# SERVICE BULLETIN

## Four-Ball Pump Changes

LOWER PUMP ENDS AFFECTED: 6720X-X

RELEASED: 3-29-99  
REVISED: 1-10-12  
REV: 00  
BULLETIN: #4-99  
FORM: 4321-2

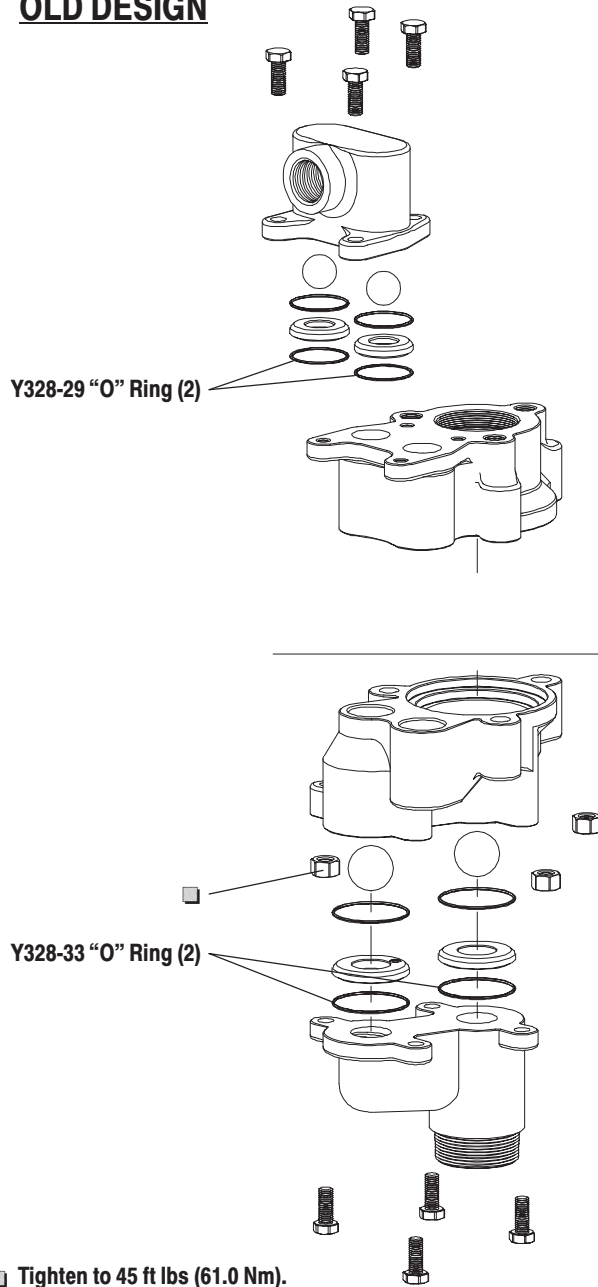
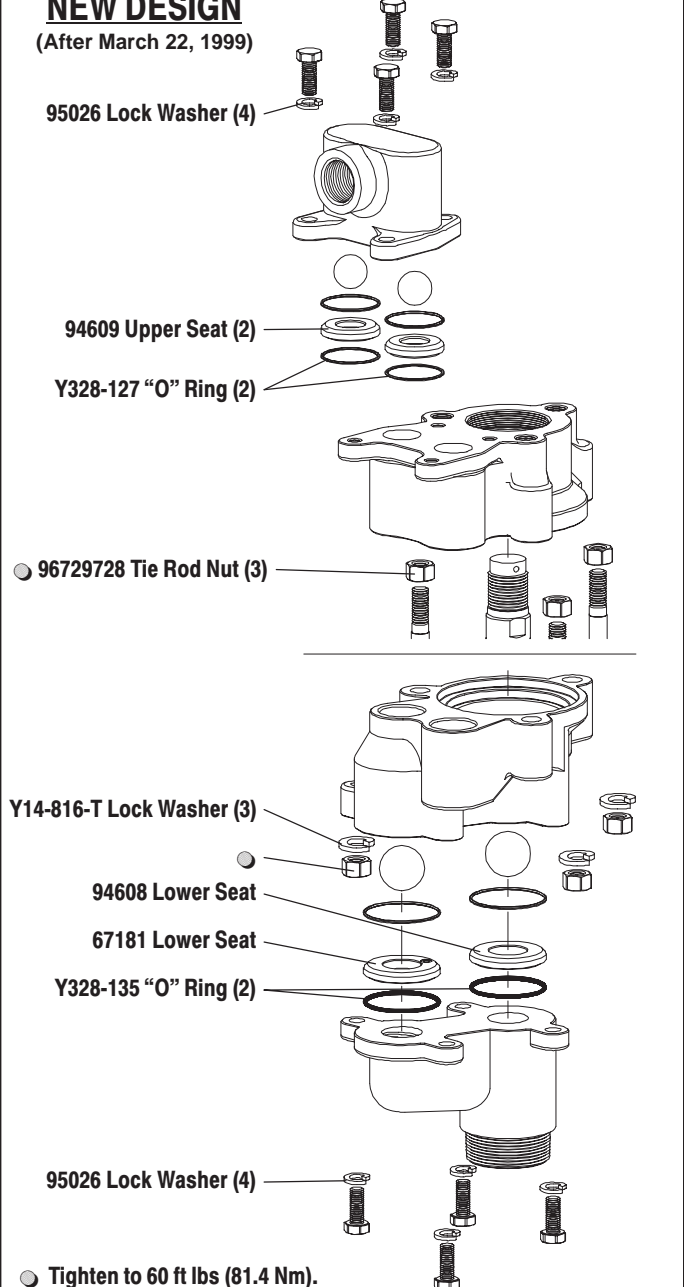
The following changes were made to 6720X-X Lower Pump End.

- 1.) Add 95026 lock washers (8).
- 2.) Add Y14-816-T lock washers (3).
- 3.) Add 96729728 tie rod nuts (3).
- 4.) Y328-29 "O" rings (2) are replaced by Y328-127 "O" rings (2).
- 5.) Y328-33 "O" rings (2) are replaced by Y328-135 "O" rings (2).
- 6.) 67181, 94608 and 94609 (2) seats have a larger machined shoulder to accept larger "O" rings.
